ASOS MODIFICATION NOTE 31 (for Electronics Technicians)

SUBJECT : ACU Memory Firmware Version 2.3 and ACU CPU Firmware 1.81

PURPOSE : To add Freezing Rain, preliminary Meteorological Aviation Report (METAR) and ASOS Controller Equipment (ACE) enhancements.

EQUIPMENT : ASOS Acquisition Control Unit (AACU)
AFFECTED

FIGURE 1

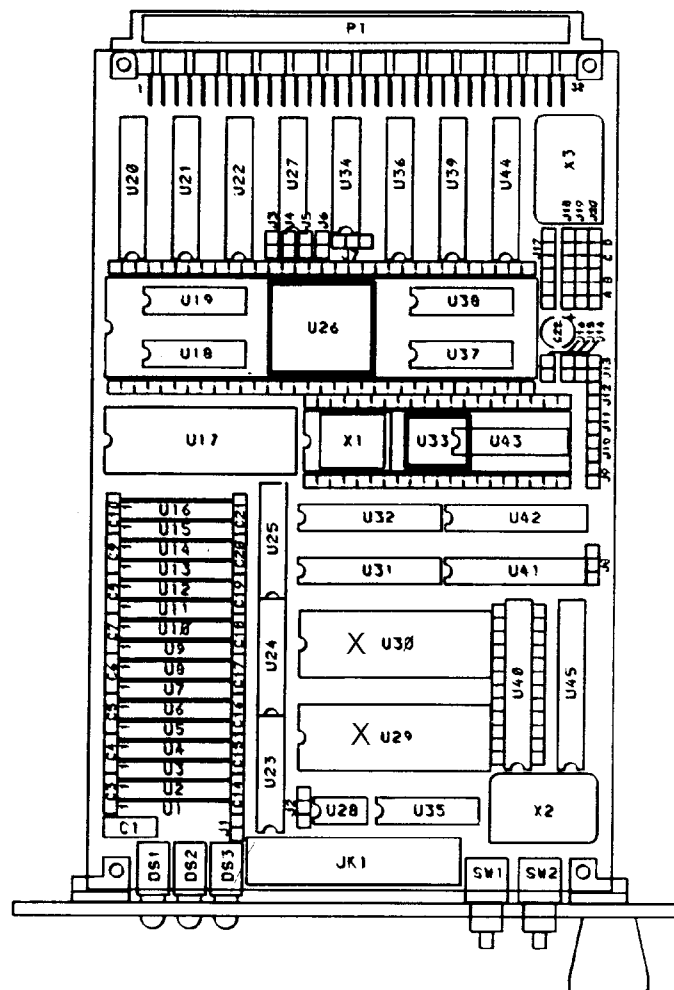
All ASOS application software is contained on the four erasable programmable read only memory (EPROM) integrated circuits (IC) on ACU memory board 1A2A3. Figure 1 illustrates the ACU memory board and identifies the four EPROMs (U8, U17, U7, and U21). The EPROMs are 32-pin dual in-line package (DIP) CMOS devices, each providing 512K x 8 bits of storage. Upgrading ASOS software requires only replacing the four EPROMs on the ACU memory board with higher revision level ICs.

Figure 1 also identifies the four additional RAM chips (U46, U47, U52 and U53). The RAM chips are 32-pin DIP CMOS devices, each providing 128K x 8 bits of storage. There will be no jumpers or switch setting changes to the board. One RAM chip is added to the top of the clock socket/chip (U52). This causes the chip to protrude into the next card slot position.

11. Using the IC insertion tool, remove the new EPROM ICs from protective packaging and insert them into the ACU memory board sockets in accordance with the following chart. Ensure that the EPROMs are installed with pin 1 (as identified by notch in top of IC) oriented toward board connector P1 and P2 as shown on Figure 1.

12. Using the IC insertion tool, remove the RAM ICs from protective packaging and insert them into the ACU memory board sockets U46, U47, U52 and U53. Ensure that the RAMs are installed with pin 1 (as identified by notch in top of IC) oriented toward board connector P1 and P2 as shown on Figure 1. U52 already has a clock chip installed. **DO NOT REMOVE THE CLOCK CHIP.** Install the RAM chip on top of the clock chip.

<u>IC socket</u>	<u>IC part number</u>
U8	62828-45002-1
U17	62828-45003-1
U7	62828-45004-1
U21	62828-45005-1
